Evaluation of proposed move for Water Right No. 9410

Proposed: Move water right no. 9410 to a new well location, 1,858 ft to the southeast.

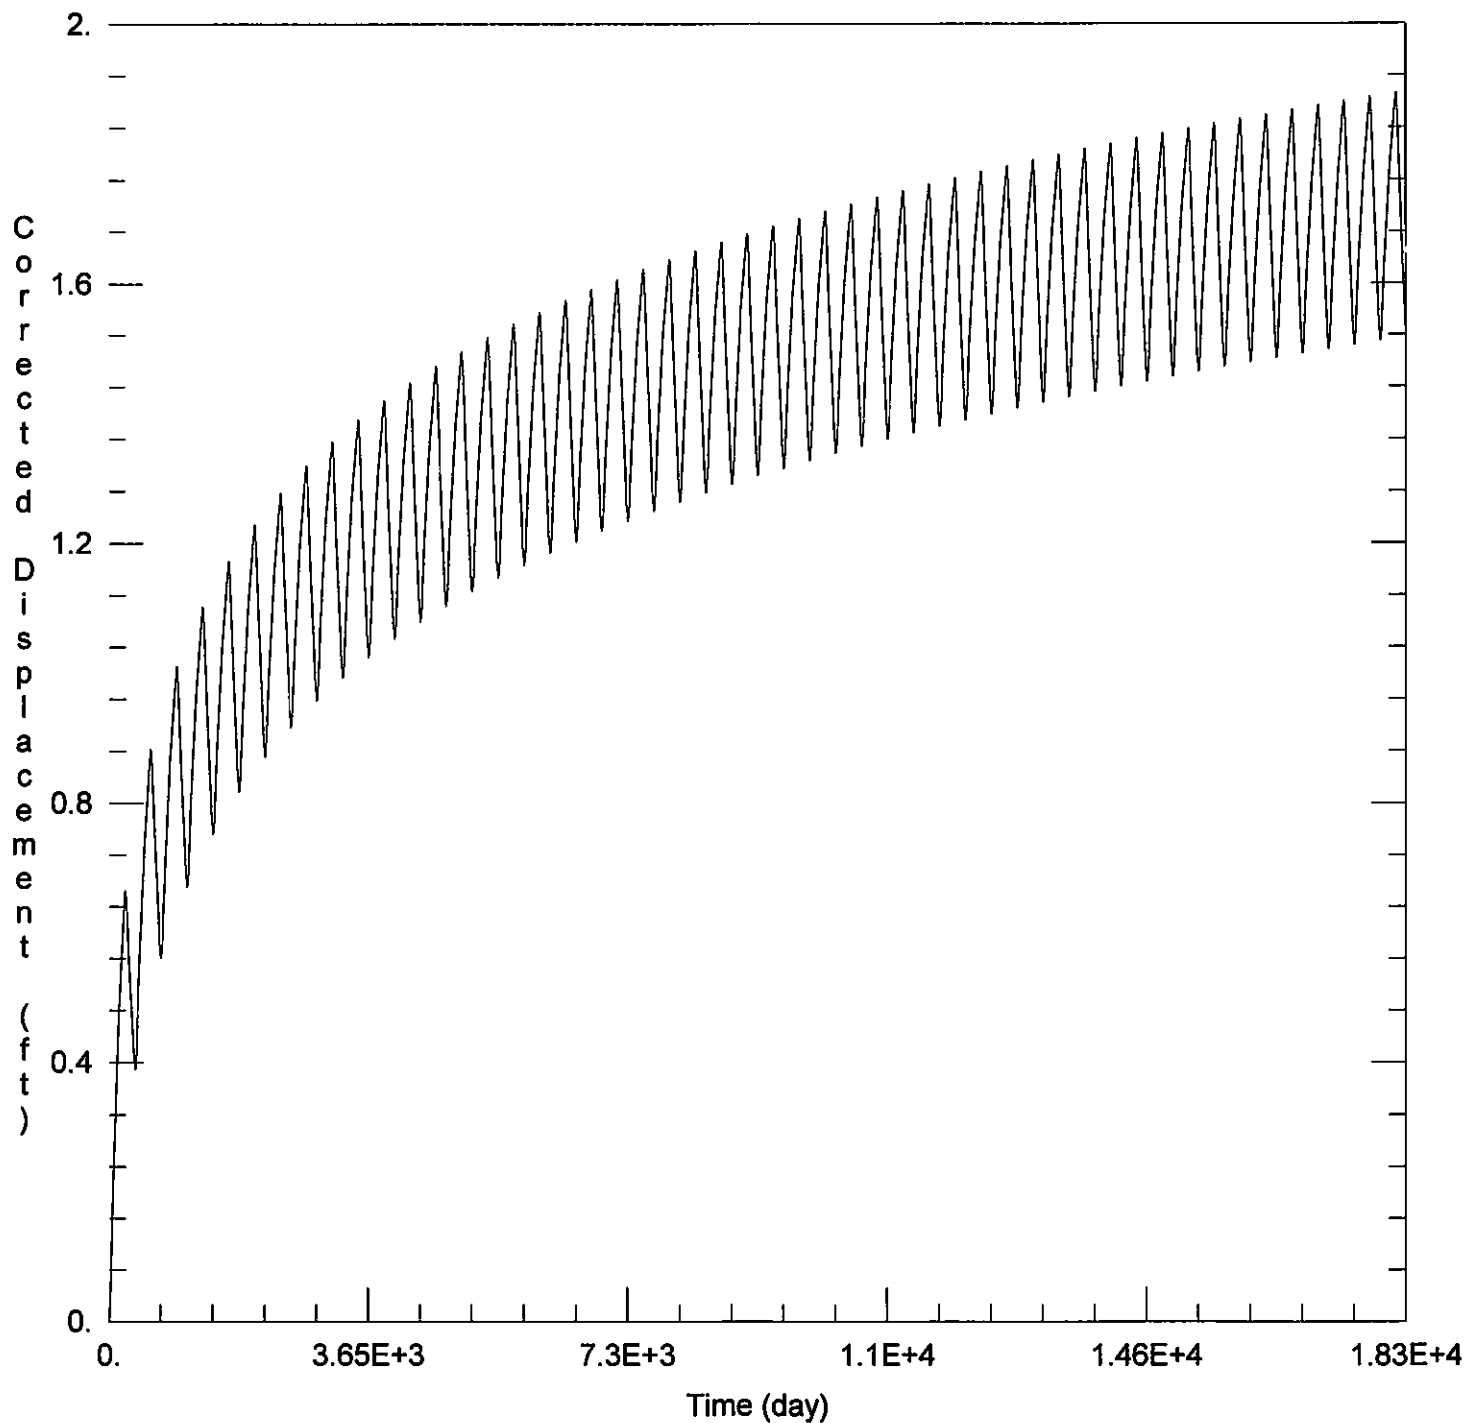
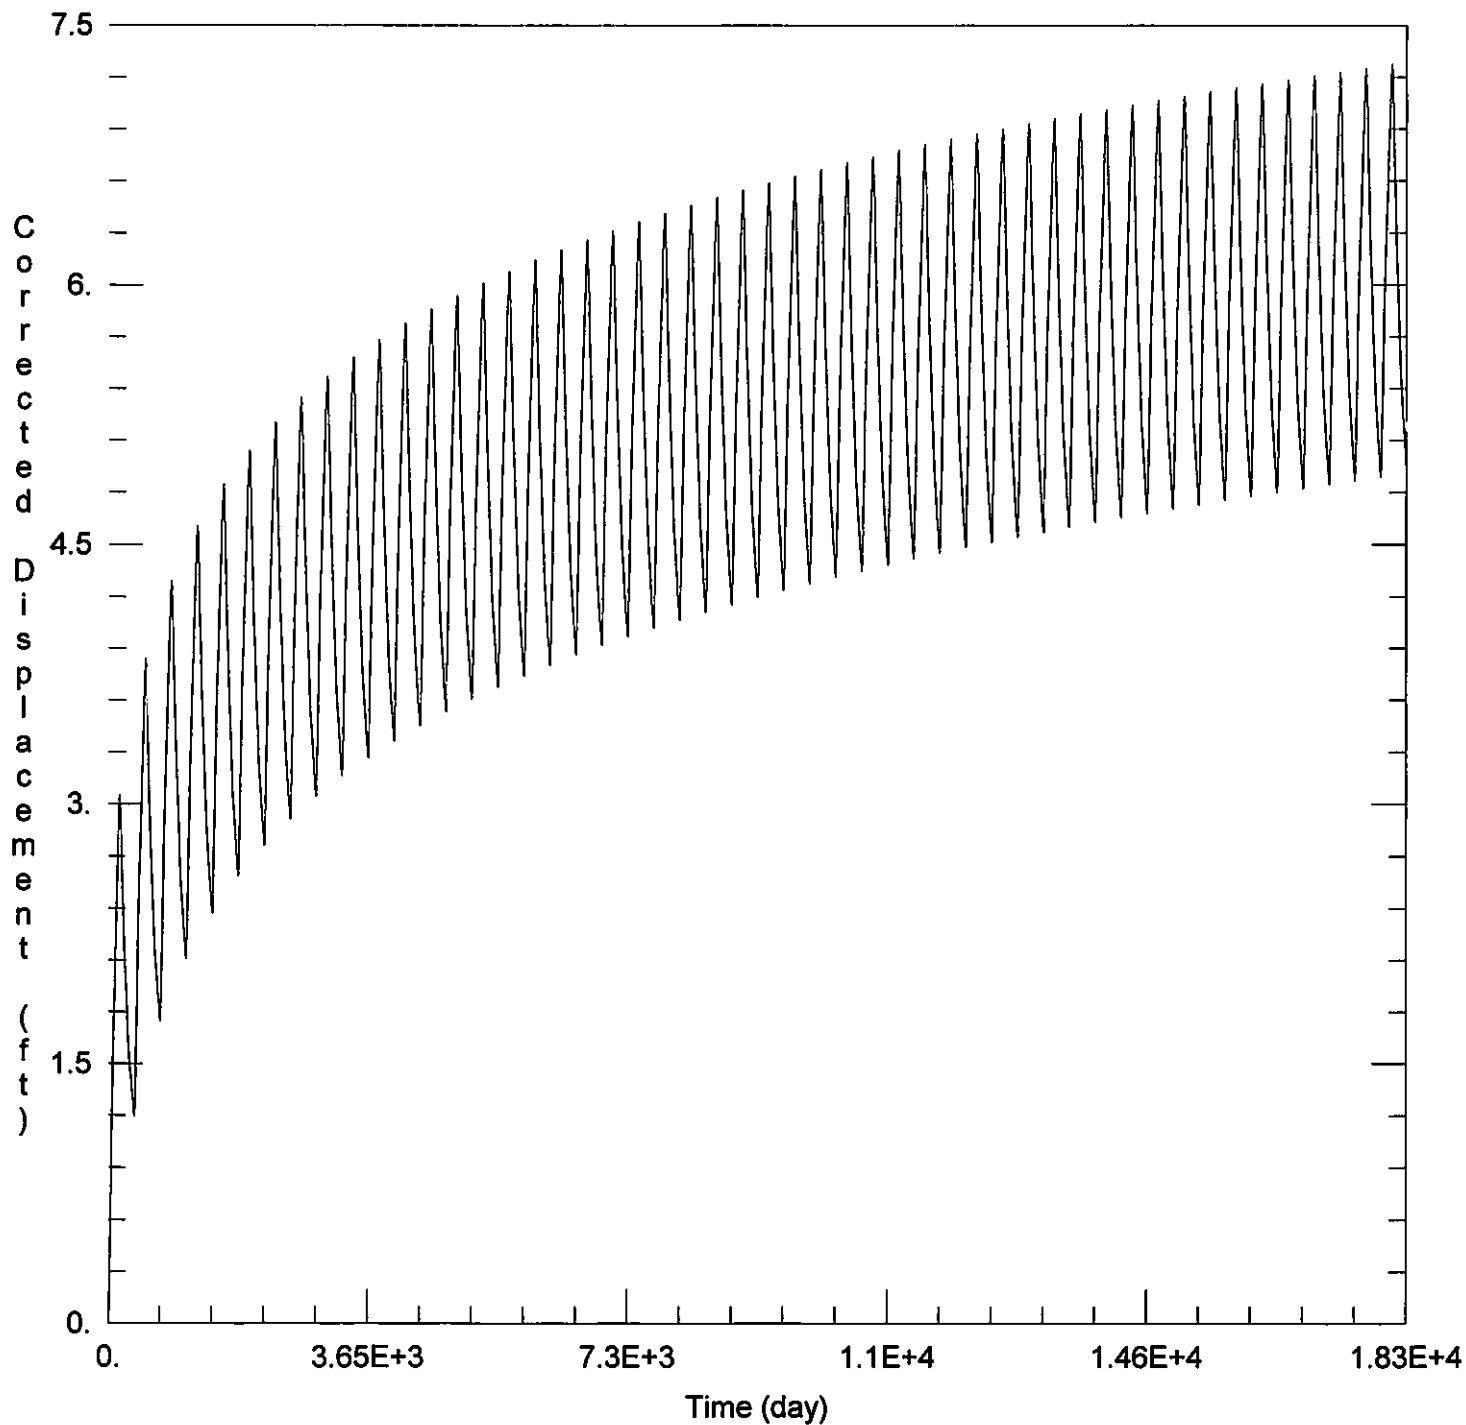
50 year Theis Analysis: The following values were used to run the analysis:

$S = 0.2371$, $T = 12,584 \text{ ft}^2/\text{day}$, $tp_{\text{current}} = 244 \text{ days}$, $Q_{\text{current}} = 418 \text{ gpm}$, $tp_{\text{proposed}} = 224 \text{ days}$,
 $Q_{\text{proposed}} = 2000 \text{ gpm}$

Theis drawdowns were calculated as follows:

29840: Drawdown from current location = 1.89 ft
 Drawdown from proposed location = 7.27 ft
 Net drawdown = 5.4 ft

Net drawdown exceeds the drawdown allowance for neighboring water right no. 29840. Critical well analysis is necessary on that well.
